Form 3160-5
(September 2001)UNITED STATES
DEPARTMENT OF THE INTERIOR
BUREAU OF LAND MANAGEMENTSUNDRY NOTICES AND REPORTS ON WELLS
Do not use this form for proposals to drill or to re-enter an
abandoned well. Use Form 3160-3 (APD) for such proposals.FORM APPROVED
OMB No. 1004-0136
Expires January 31, 2004

DODD FEDERAL UNIT #21

MARROB ENERGY CORPORATION PROPOSES TO PLUG AND ABANDON AS FOLLOWS:

BEFORE

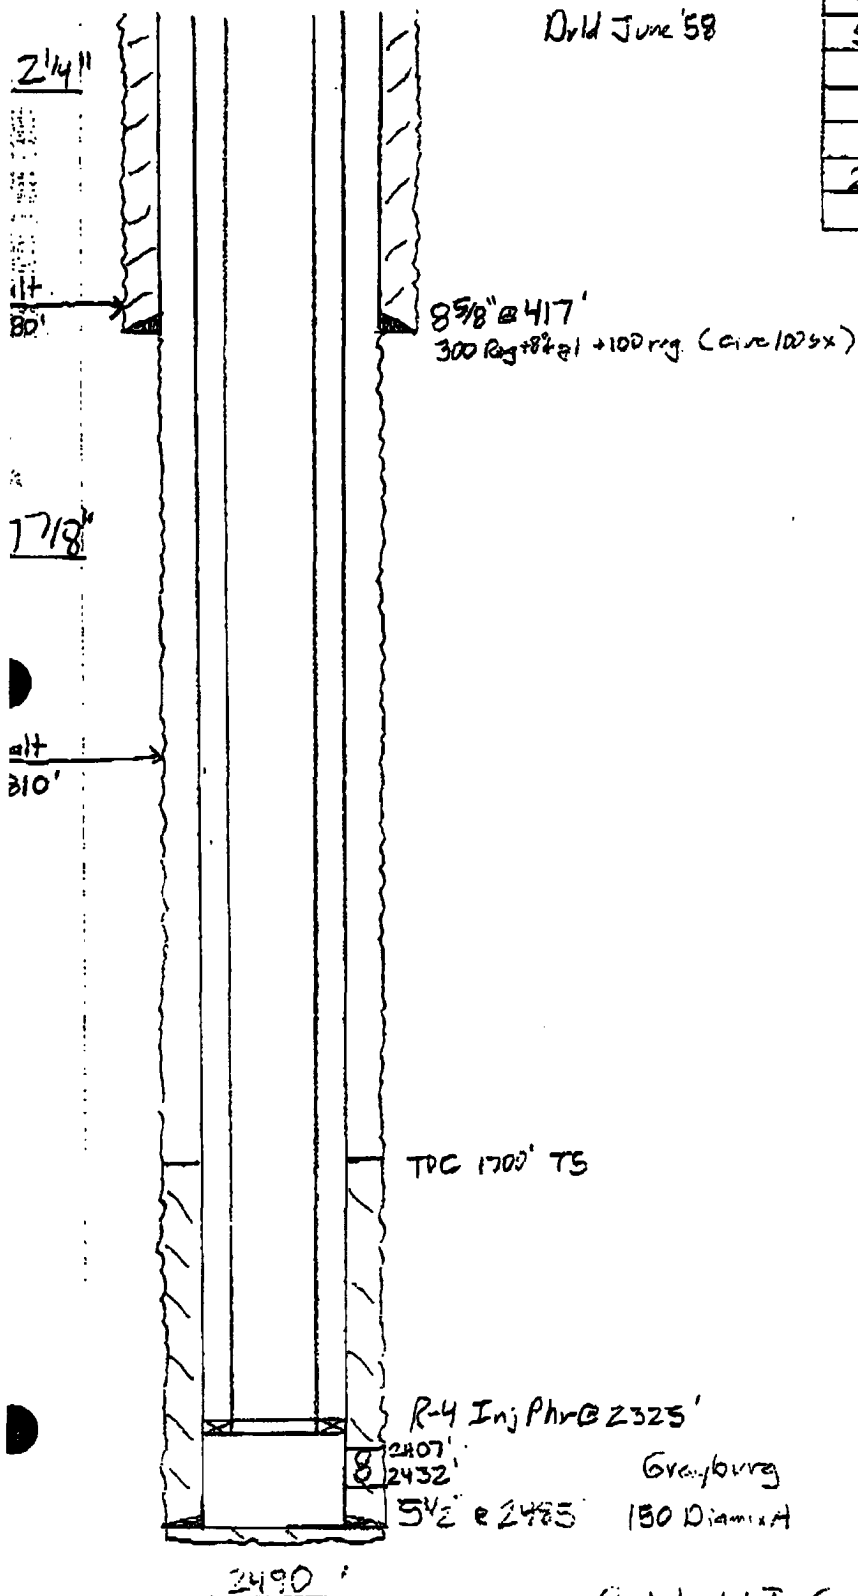
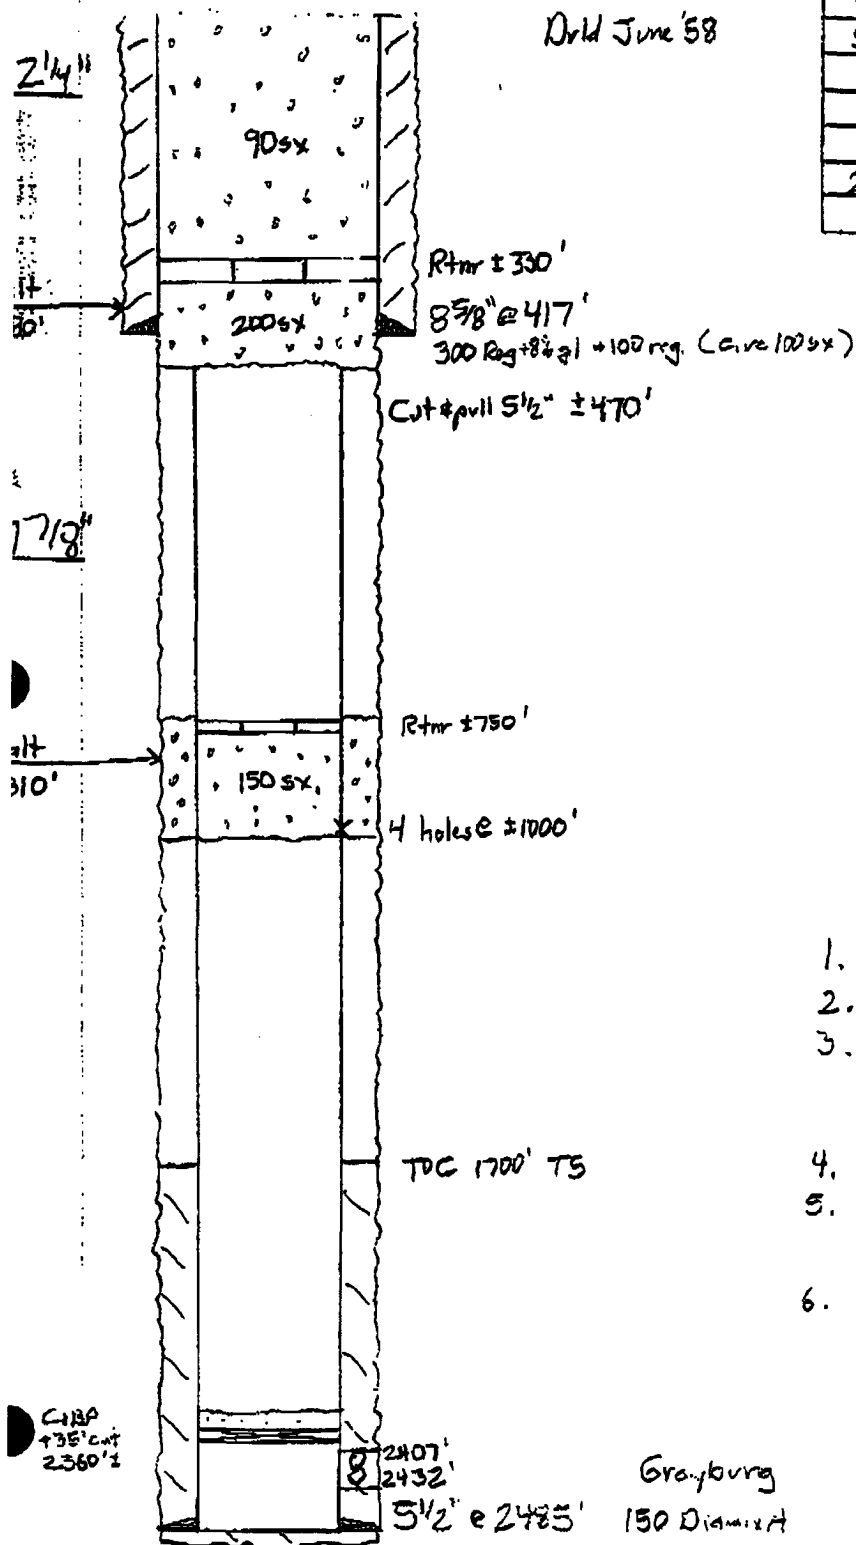
1. CIBP + 35' cut ± 2360'
2. Fill hole with mud
3. Perf 4 holes ± 1000'
 Rtnr ± 750'. Pump 150 sx in/out
 5 1/2" from 750'-1000' (base salt)
4. Cut & pull 5 1/2" @ ± 470'
5. Rtnr ± 330' in 8 5/8"
 Pump 200 sx below retainer.
6. Spot 90 sx 330' to surface
 inside 8 5/8"
